Proposal for the 09 series of amendments to UN Regulation No. 17 (Strength of seats)

Submitted by the Working Party on Passive Safety*

09 series of amendments to UN Regulation No. 17 (Strength of seats)

Model B

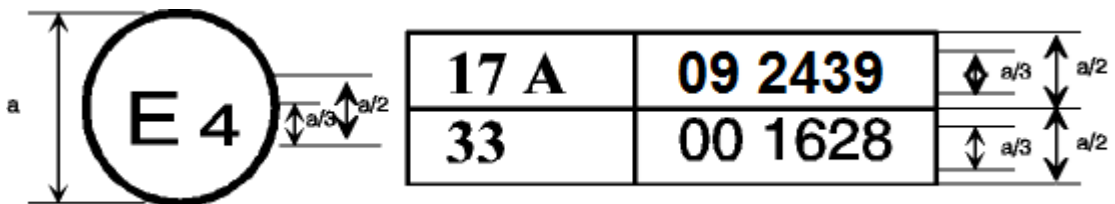
Annex 2, amend to read:

The above approval mark ... approval number 092439. The first two digits of the approval number indicate that the Regulation already contained the 09 series of amendments at the time of approval.

Model D

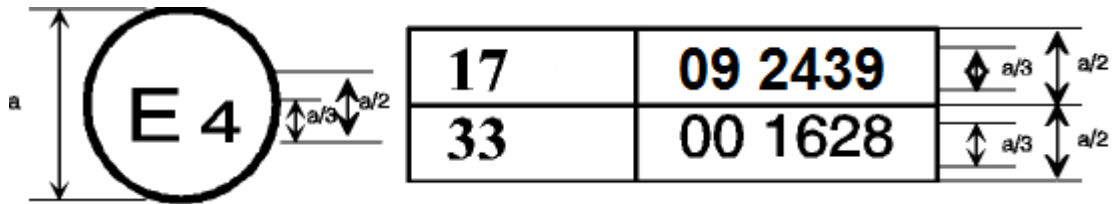
The above approval mark ... included the 09 series of amendments but UN Regulation No. 33 was still in its original form."
